**Airways New Zealand Petition**  
**to**  
**The Director of Civil Aviation**  
**to**  
**1. amend the Wellington CTR/C and CTA/C**  
**and**  
**2. delete and add VRPs**  
**and**  
**3. amend transit lane NZT656 Porirua**  
**and**  
**4. designate a new transit lane near Turakirae Head**

**14 December 2017**

Prepared by: John Wagtendonk  
ATS Policy and Standards  
Airways New Zealand  
03 3581620  
[j.wagtendonk@airways.co.nz](mailto:j.wagtendonk@airways.co.nz)

Diagram 13 Requested new WN CTR sectors.

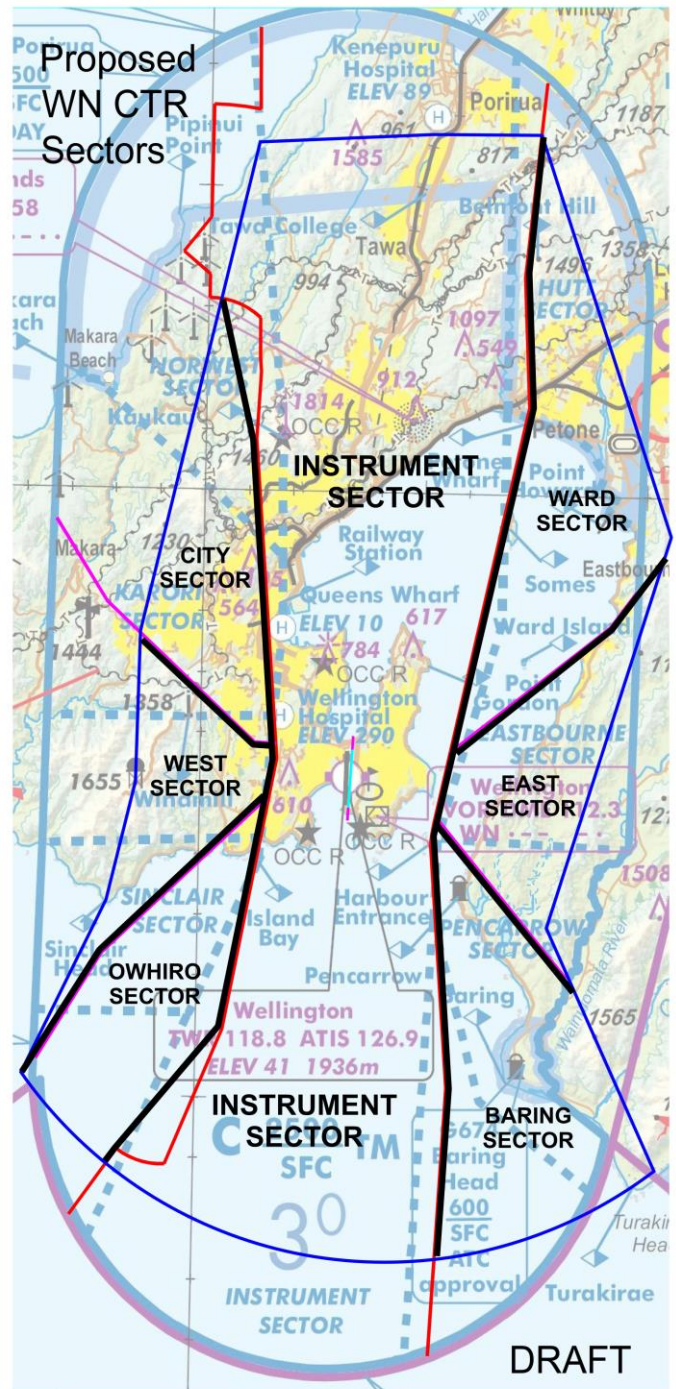
Along with changes to the WN CTR, Airways is requesting that all of the existing WN CTR sectors are disestablished and replaced with the seven sectors depicted in black in Diagram 13 below.

Feedback received from a helicopter operator at Queens Wharf heliport (NZQW) raised concern about the impact a new instrument sector would have on their operations to and from Queens Wharf and the Lambton ARR/DEP Area and associated LAMBTON ARRIVAL and LAMBTON DEPARTURE (refer AIPNZ NZQW AD 2 – 35.1).

The Lambton ARR/DEP Area infringes the existing Instrument Sector, the requested combined instrument sector depicted opposite and all of the individual sectors for the IFR procedures.

Neither the combined sector nor any of the individual sectors could be made narrower so that they would not be infringed by the Lambton ARR/DEP Area.

The on-going ATC management of helicopter operations at NZQW needs to be determined. Airways sees that process as being separate from this petition for CTR and depicted instrument sector change.
